TO: Township of West Orange Planning Board

FROM: Malvika Apte, PP, AICP, Planning Board Planner
Megan Adam, AICP Candidate, Associate Planner

RE: PB Application 25-10
Planning Review # 1
457 Mount Pleasant Avenue (Trader Joe's)
Block 157, Lot 5
Preliminary & Final Major Site Plan Approval and "C" Variances Approval

DATE: November 12, 2025

Subject Site Aerial
Source: NJ Geo Web

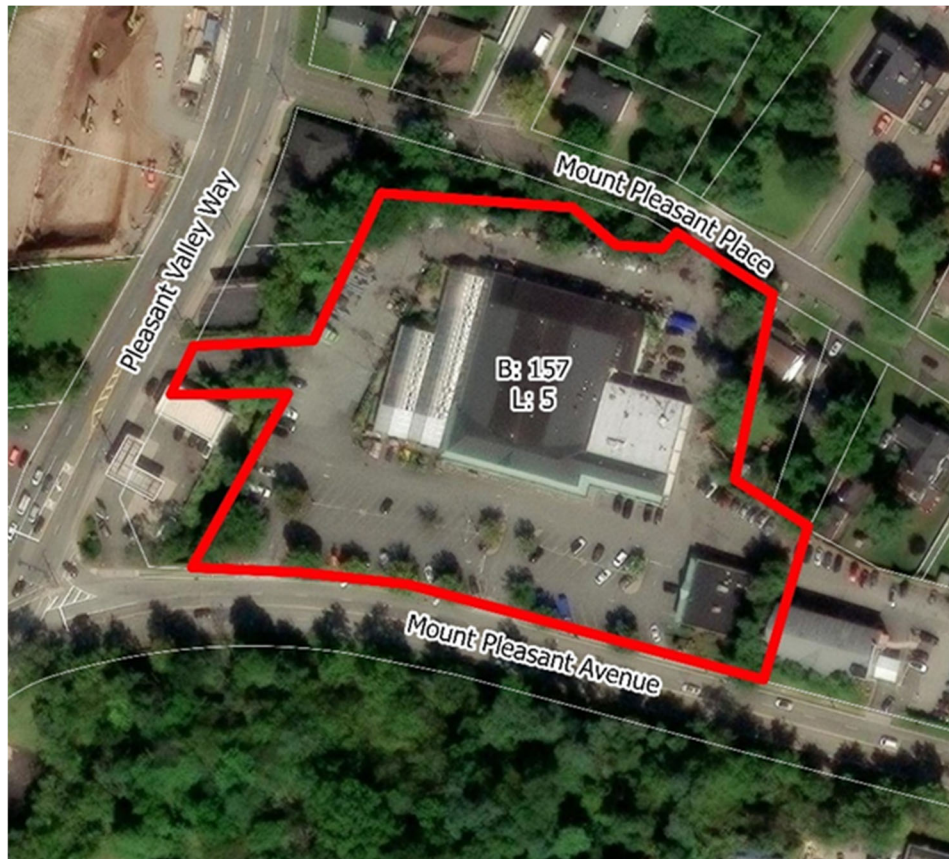
The subject property is currently developed with a 29,000-square-foot one-story masonry strip mall (the "Main Retail Building") with a pitched roof. **It appears there was a one story attached greenhouse to the structure that appears to no longer exist, applicant should confirm.** A 3,200-square-foot one-story brick retail building (the "Smaller Retail Building") detached from the main building is located southeast of the property. The entire lot is developed with a surface parking lot comprising of approximately 165 spaces. The Main Retail Building is partially occupied and includes vacant tenant spaces. Active tenants include Martial Arts, Julio's Restaurant, Party Wines liquor store, Crystal Cleaners, Coco Nails, and Quick Shop Food and News. The smaller retail building contains two personal service establishments, bagels and pizza fast food stores.

According to the floor plans provided, the Trader Joe's store will encompass the entirety of the vacant tenant space, along the western portion of the Main Retail Building. **Applicant should confirm that all the existing active tenant spaces within the eastern sections of the building are to remain.**
